## Division of Solid and Infectious Waste Management

### Response to Comments

#### Rules Pertaining to the Design of Facility Components: Chapter 3745-511

Cross section of landfill bottom is not to scale

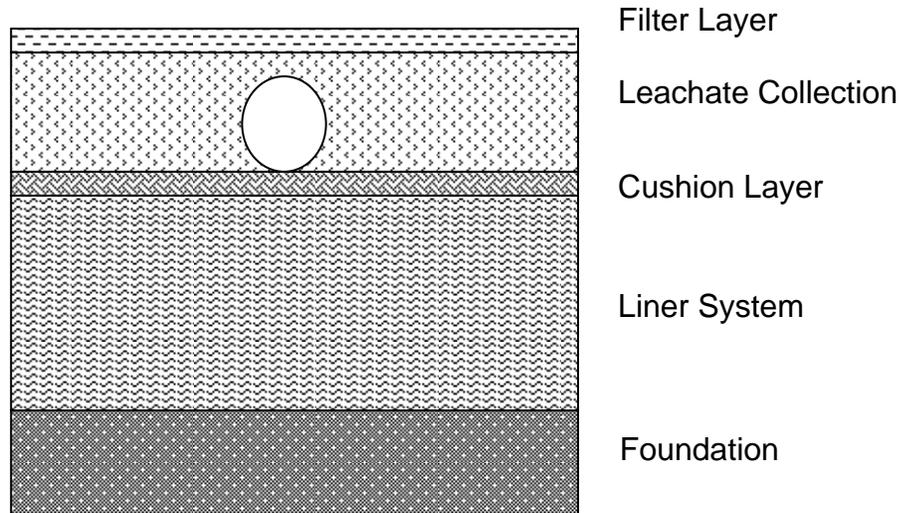
**Comment #998: 520-420(C): How thick is the cushion layer? Can you provide a cross section from the bottom up of the landfill design for clarity? What is a Mullen burst? (Kathy Trent, Waste Management)**

**Response:** Thickness of the cushion layer will vary, but generally for geotextiles it will not exceed 1/8 inch. Mullen Burst was removed from the rule. The Mullen Burst measures the force required to burst through a fabric. The Mullen Burst test uses a circular material sample that has been clamped over a diaphragm and inflated with oil. Pressure is applied until the fabric bursts. The

pressure (in pounds per square inch) at which the fabric bursts is the bursting strength.
